TENNESSEE VALLEY AUTHORITY  
BROWNS FERRY NUCLEAR PLANT (BFN)  
Units 2 and 3

PROPOSED IMPROVED TECHNICAL SPECIFICATION CHANGE TS-393, SUPPLEMENT 1  
RESPONSE TO REQUEST FOR ADDITIONAL INFORMATION  
MARKED PAGES

PROPOSED IMPROVED TECHNICAL SPECIFICATION CHANGE TS-393, SUPPLEMENT 1  
REVISED PAGES

Figure 3.4.9-1  
Pressure/Temperature Limits

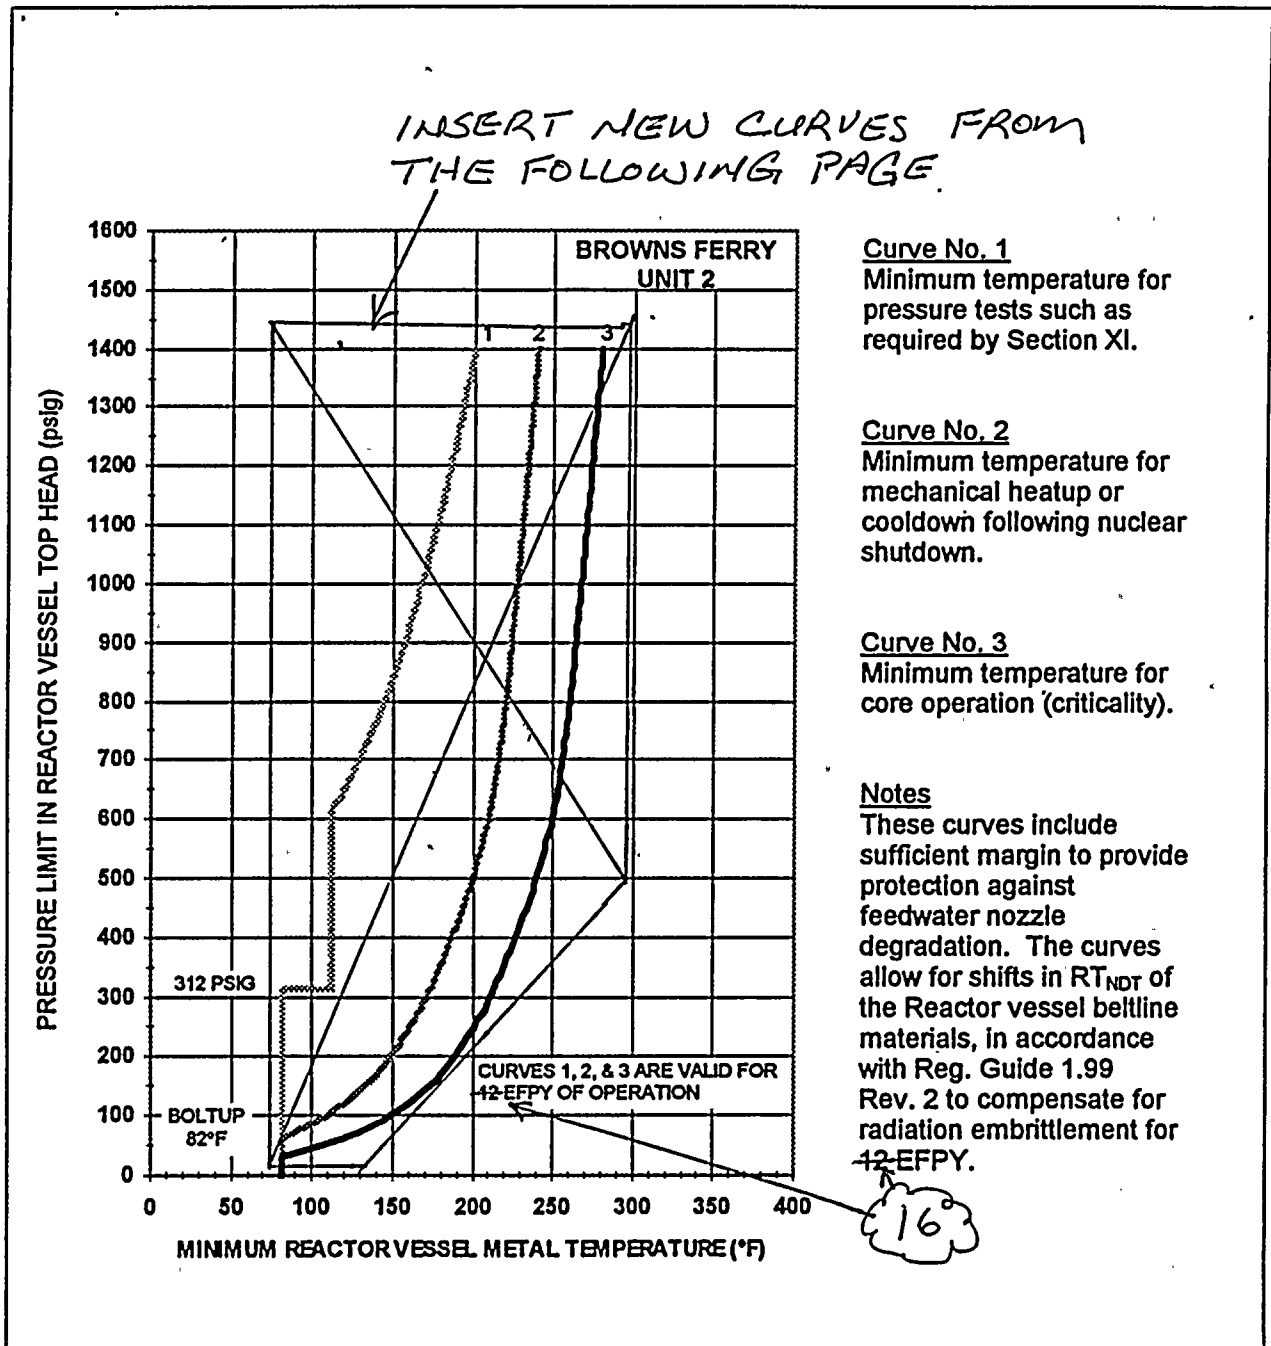
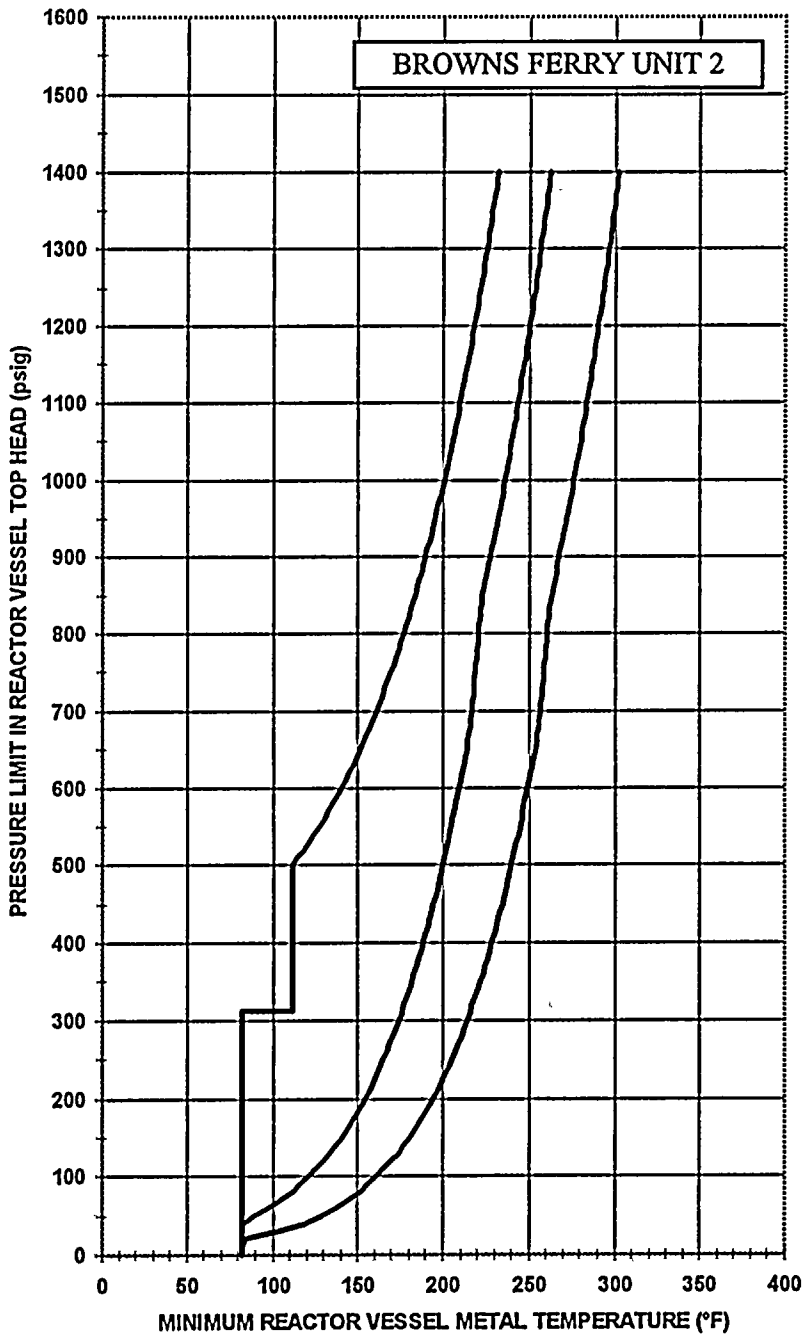
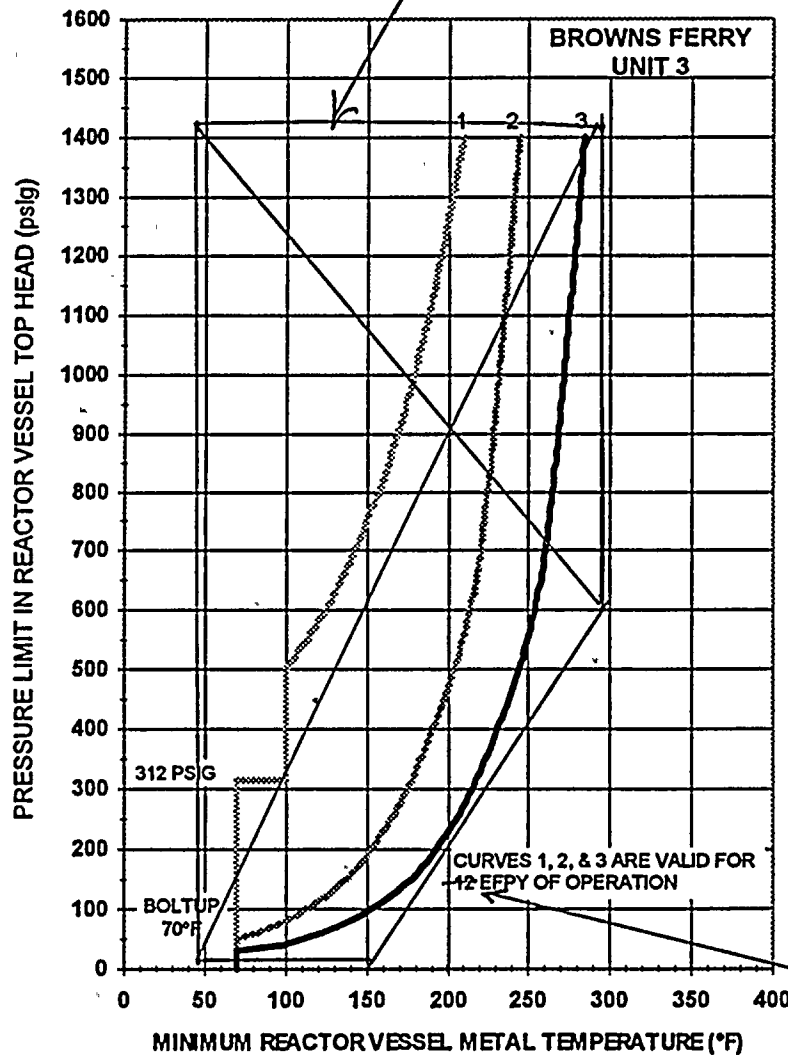
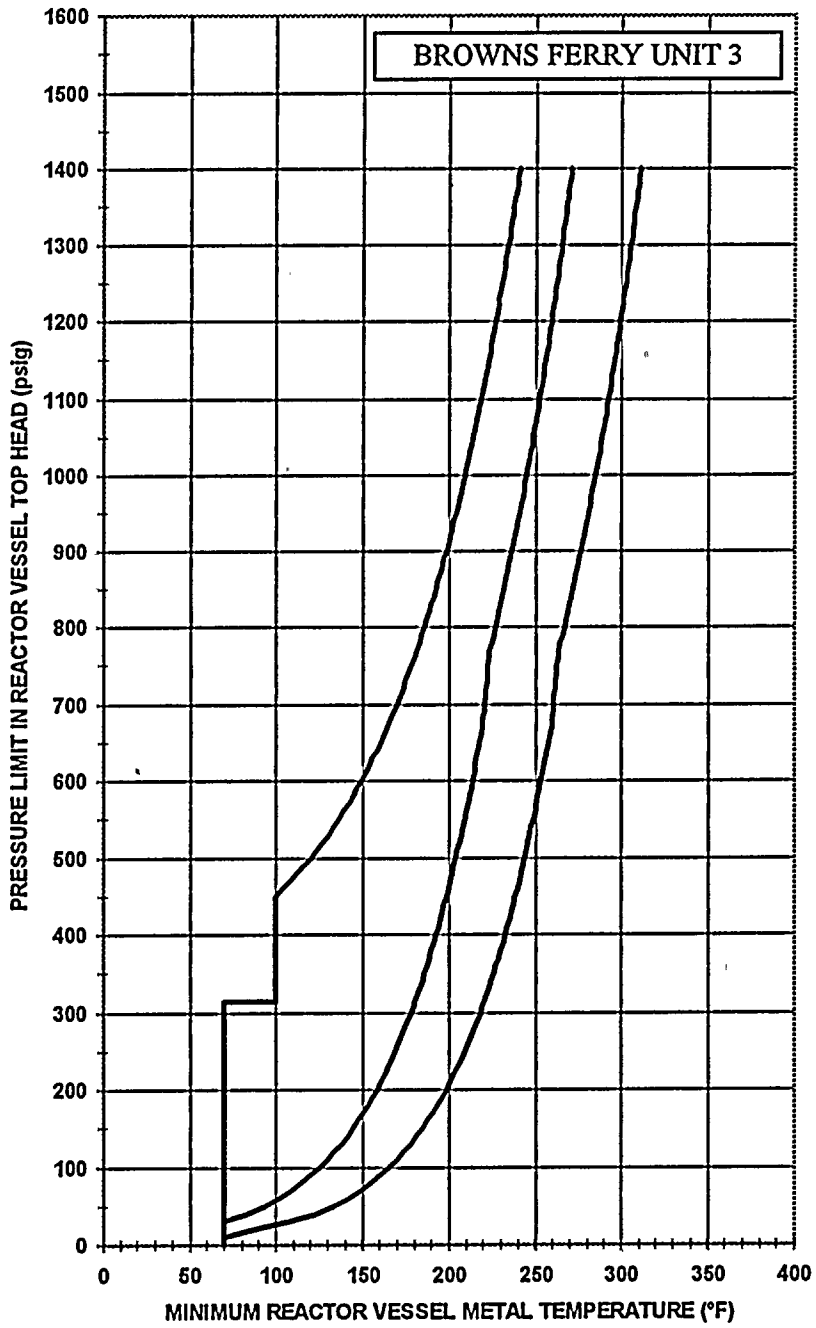
INSERT NEW CURVES FROM  
THE FOLLOWING PAGE

Notes  
These curves include  
sufficient margin to provide  
protection against  
feedwater nozzle  
degradation. The curves  
allow for shifts in  $RT_{NDT}$  of  
the Reactor vessel beltline  
materials, in accordance  
with Reg. Guide 1.99  
Rev. 2 to compensate for  
radiation embrittlement for  
12 EFPY.

Figure 3.4.9-1  
Pressure/Temperature Limits

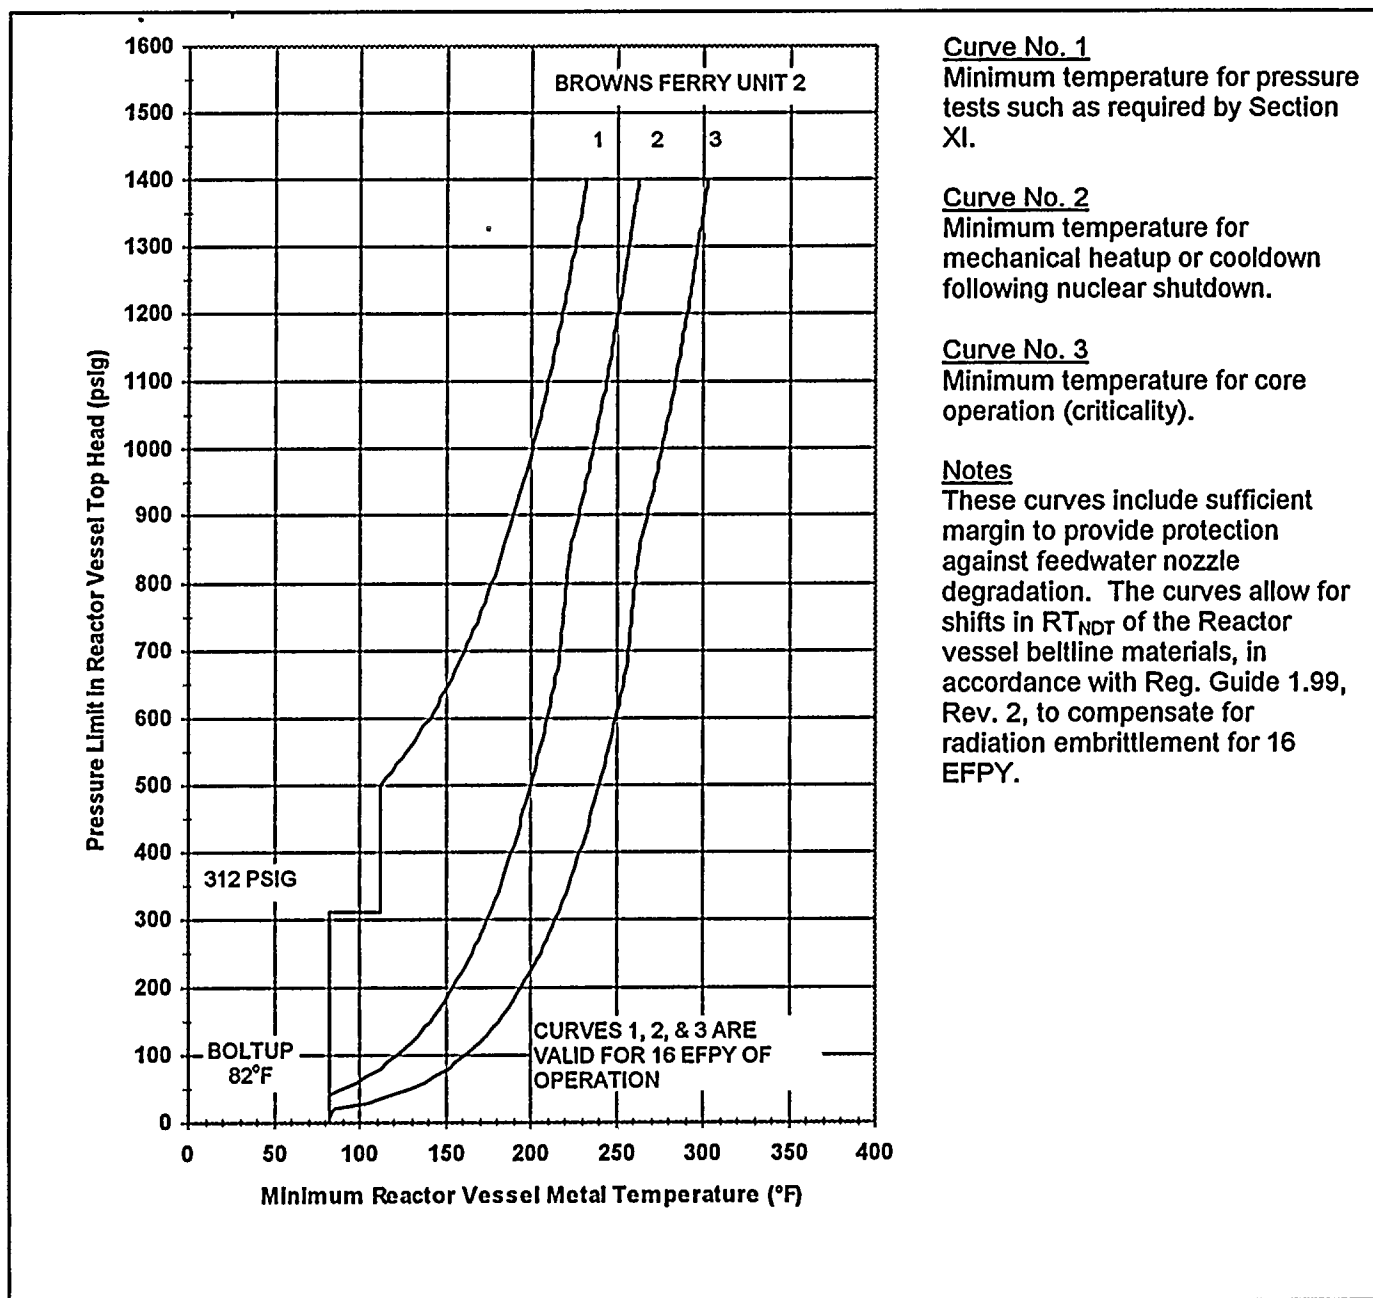
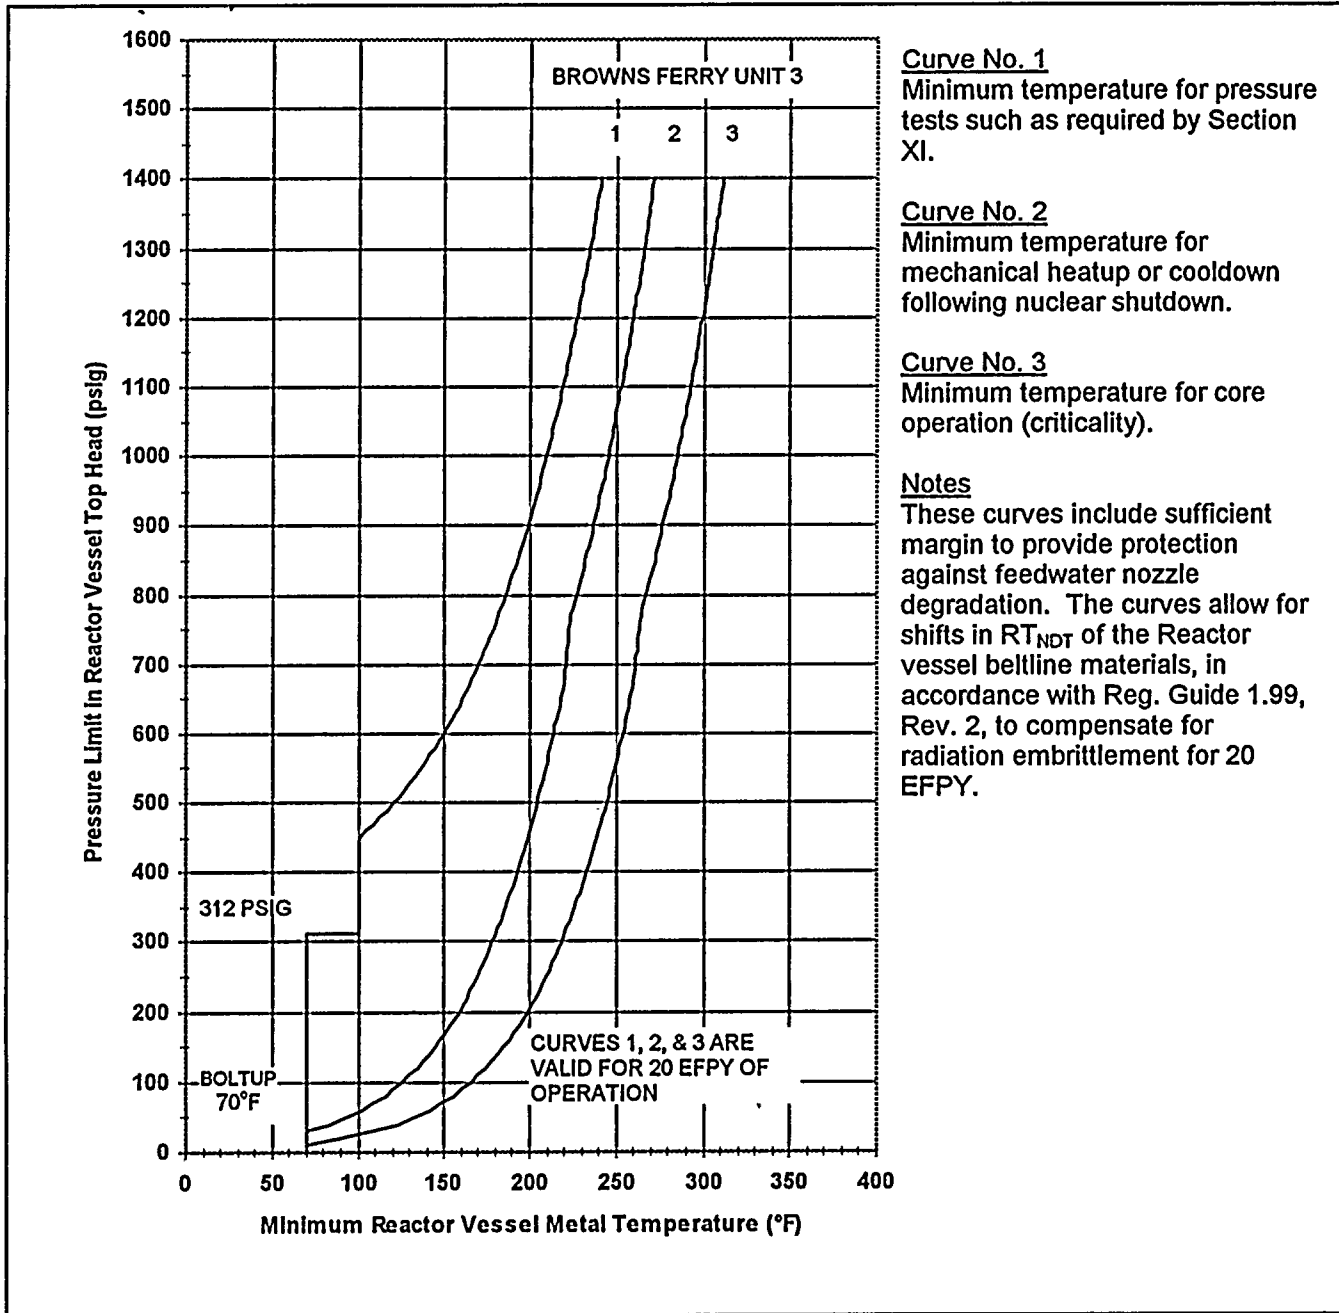
Notes  
These curves include sufficient margin to provide protection against feedwater nozzle degradation. The curves allow for shifts in  $RT_{NDT}$  of the Reactor vessel bellline materials, in accordance with Reg. Guide 1.99, Rev. 2, to compensate for radiation embrittlement for 16 EFPY.
